# West Burton Solar Project

### Figure 8.18.3: Landscape and Ecology Mitigation and Enhancement Measures West Burton 3

### Revision A

Document reference: APPEX1/WB6.4.8.18.3 A

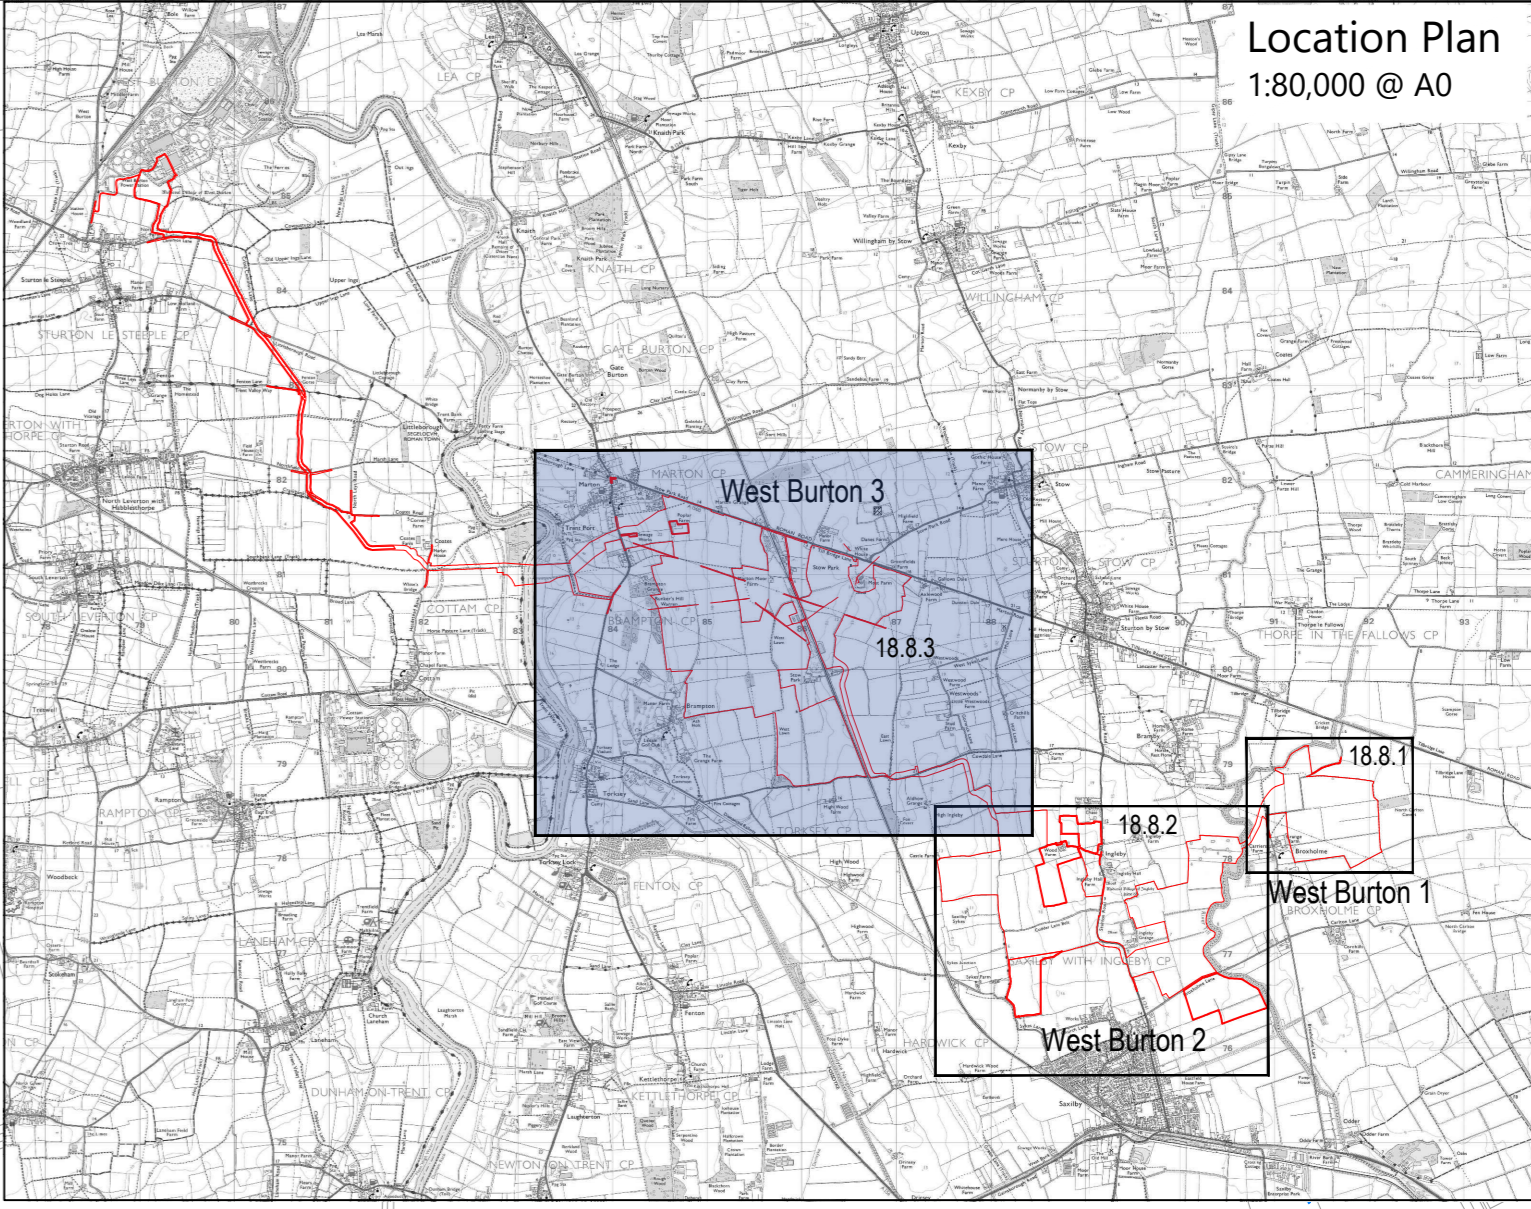
Figure Reference	Page	Description of Changes	Reason for Revision
<a href="#">WB6.4.8.18.3_A</a>	<a href="#">3</a>	<p><a href="#">Change to spelling of 'enhancement'.</a></p> <p><a href="#">Amend the wording of hedgerow removal in the key from 'Existing hedge to be removed' to 'Existing hedge to be removed permanently'.</a></p> <p><a href="#">Offset calculations from drains.</a></p> <p><a href="#">Changes to hedgerow removal locations.</a></p> <p><a href="#">Changes to proposed woodland planting.</a></p>	<p><a href="#">To correct a typo.</a></p> <p><a href="#">For clarity.</a></p> <p><a href="#">For clarity.s</a></p> <p><a href="#">For clarity.</a></p> <p><a href="#">In response to changes to proposed cable route and tracks</a></p>
